DEVELOPMENT NAME: WAIT AVE AGE-TARGETED SINGLE-FAMILY ATTACHED

REV #	DESCRIPTION	DATE	BY
1	TOWN OF ROLESVILLE COMMENTS	6/29/2021	FLM

SKETCH PLAN
C-1
SHEET 1 OF 1

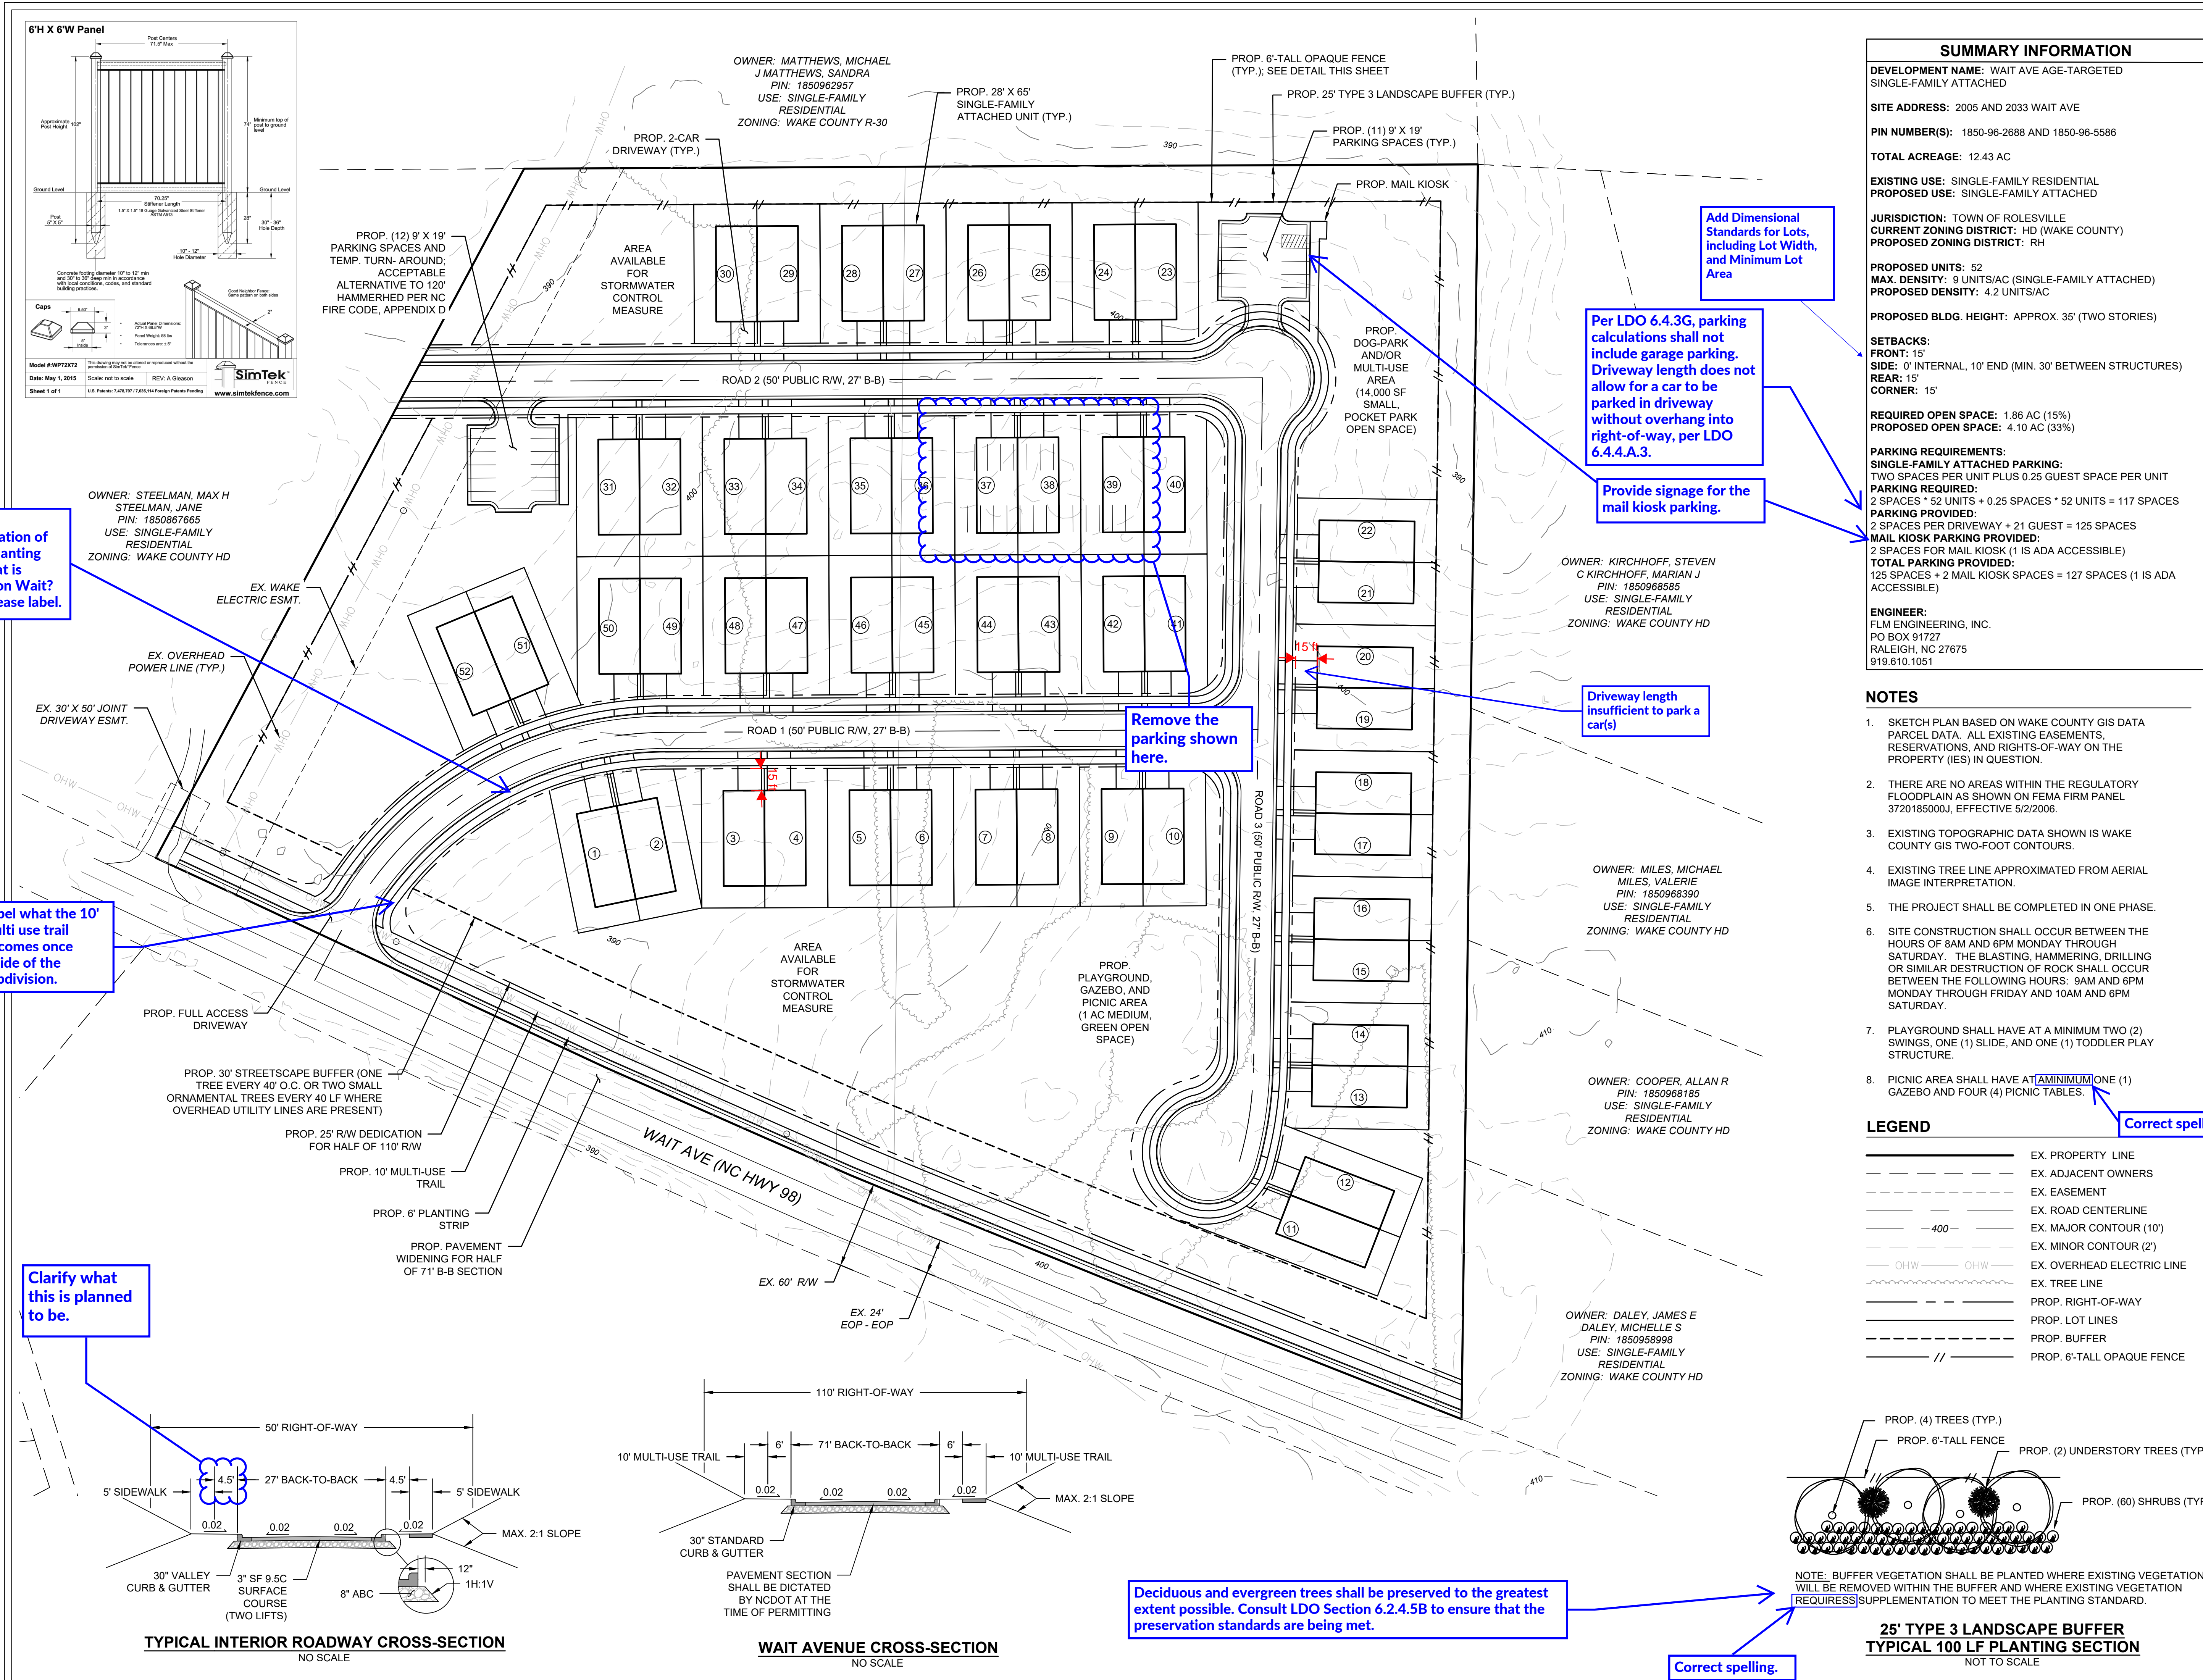
Is this a continuation of the 6' planting strip that is shown on Wait? If so, please label.

Label what the 10' multi use trail becomes once inside of the subdivision.

Clarify what this is planned to be.

Add Dimensional Standards for Lots, including Lot Width, and Minimum Lot Area

Per LDO 6.4.3G, parking calculations shall not include garage parking. Driveway length does not allow for a car to be parked in driveway without overhang into right-of-way, per LDO 6.4.4.A.3.

Provide signage for the mail kiosk parking.

Driveway length insufficient to park a car(s)

Remove the parking shown here.

Correct spelling.

Correct spelling.
